Interactive comment on “Assessing the hydrologic restoration of an urbanized area via integrated distributed hydrological model” by D. H. Trinh and T. F. M. Chui

D. H. Trinh and T. F. M. Chui

Received and published: 28 July 2013

Fig. 1. Groundwater depth, infiltration rate and groundwater recharge across bio-retention systems with different soil hydraulic conductivity. Results are from 12 hours after largest rainfall event (130mm)

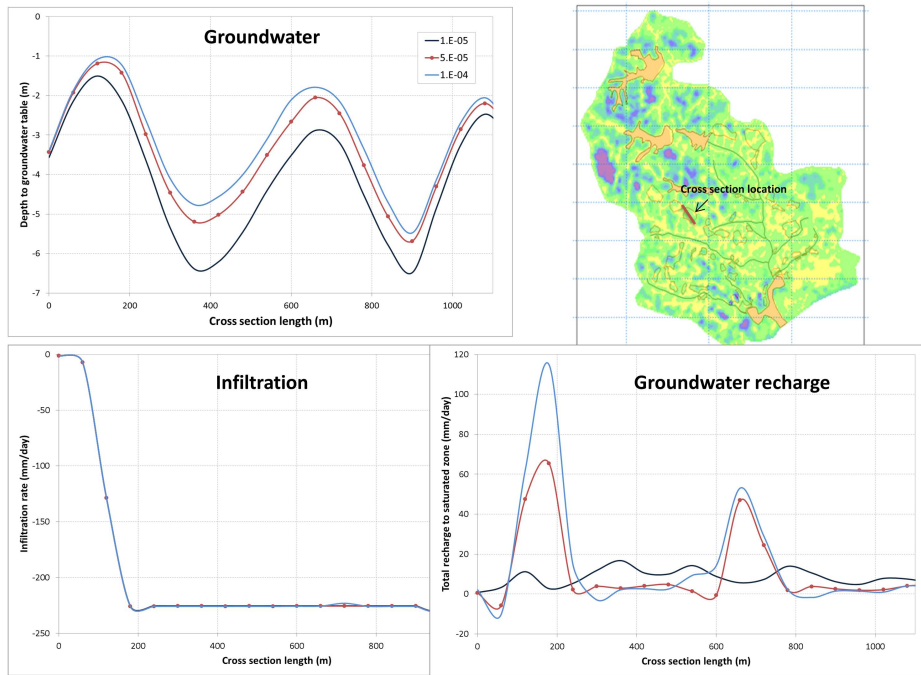
- Page 4108, line 23: the hydraulic conductivity of the soil is very similar to that of soil in bio-retention systems; I would have expected bio-retention systems to have larger hydraulic conductivity, of the order of 150-200 mm per hour (instead of about 40 mm per hour as used by the Authors).

- Page 4115, lines 9-14: according to the chosen parameters, the hydraulic conductivity of bio-retention systems is similar to that of the surrounding soil. This allows water to percolate into the surrounding soil, without accumulating in the systems. I would consider to increase the soil hydraulic conductivity of bio-retention systems to see the effect of recharge.

- Secondly, in response to the referee's comment, we have also carried out two more simulations using bio-retention systems with soil hydraulic conductivity of 5×10^{-5} m/s (180 mm/hr) and 10^{-4} m/s (360 mm/hr) which are higher than the original value of 10^{-5}

m/s (36 mm/hr). The results show that the difference in outlet discharge among the scenarios is insignificant. Taking a bio-retention system at the centre of the catchment as an example, Fig. 1 presents the groundwater table, infiltration rate and groundwater recharge across the system 12 hours after the largest rainfall event in the simulated year. This event has a rainfall depth of 130 mm and an intensity of 26 mm/hr. The infiltration rates of the different scenarios are the same, as the rainfall intensity is lower than all the soil hydraulic conductivity values. There is more recharge to the saturated zone at that particular moment leading to a higher groundwater table in the scenario with higher soil hydraulic conductivity. However, the total recharges of all scenarios reach the same values eventually. The temporal difference in groundwater recharge is because rain water requires different duration to travel through the unsaturated zone to reach the saturated zone depending on the soil hydraulic conductivity. Therefore, we believe the original soil hydraulic conductivity of bio-retention system is reasonable as increasing soil hydraulic conductivity does not affect the overall recharge amount. We will add the information above in the revised manuscript.

Fig. 2. Groundwater (GW) table depth and vegetation distribution Marina-like catchment

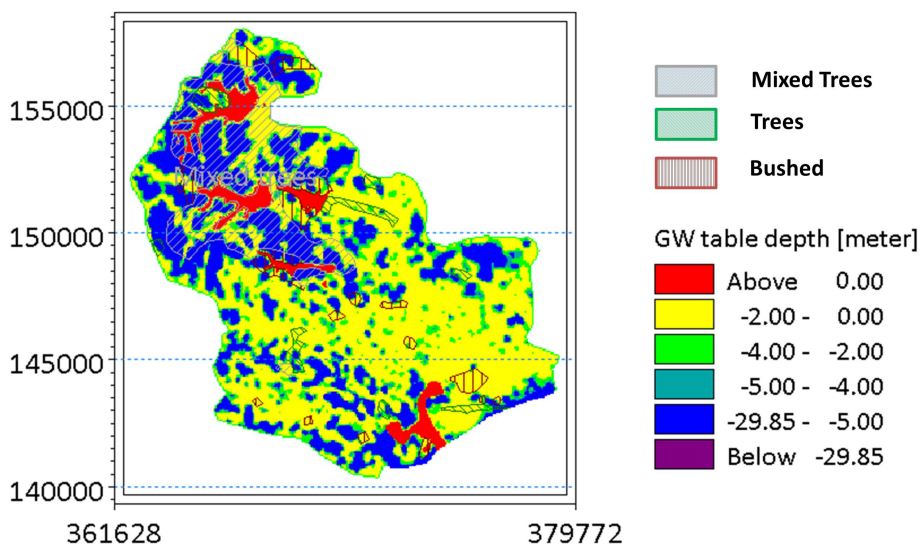
12. About the root depths of vegetation: Table 1: the root depths are well below the water table; this is unlikely, since many species would suffer under such conditions. The Authors should provide a reference to justify this choice.

[Response] According to Singapore National Parks Board (Npark), tree height in Singapore varies in the range from 4 meters to more than 20 meters (NPark, 2011). Based on the relationship between tree height and root depth from Štofko (2010), the root depth is approximately 3.5 meters for a 4.0 meter tree. In addition, a recent survey in Singapore shows that the root of vegetation can be more than 3 meters (Ngo et al., 2013). Thus, we believe that our assumption on root depth is reasonable. Furthermore, most of the vegetation with deep roots locates in the upstream of the catchment where the groundwater table is mostly below 5 meters (Fig 2). The rest, locating in the downstream area, either has shallower root or is wetland vegetation that is more resistant to flooding conditions.
